Stormwater/Effluent Runoff & Environmental Concerns

Prepared by Neighbors for the Protection of Willow Beach Slough
Possum Kingdom Lake, Texas
May 24, 2021

Before...

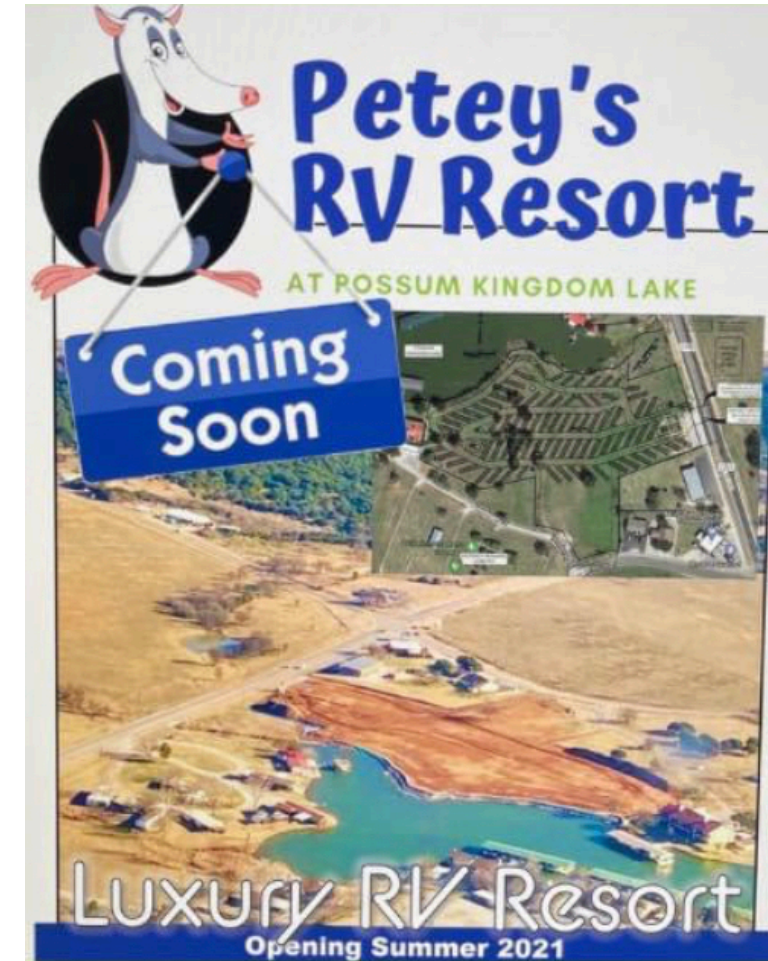
Soil Disturbance, Minimal Vegetation, and Impervious Surfaces

- Every inch of the soil on the property has been disturbed
- All vegetation has been removed
- Caliche roads and pavement to cover the property
 - Where will the vegetation be?
 - Vegetation and undisturbed soil allows for:
 - Increased saturation
 - Impeded runoff flow
 - Adequate stormwater runoff filtration
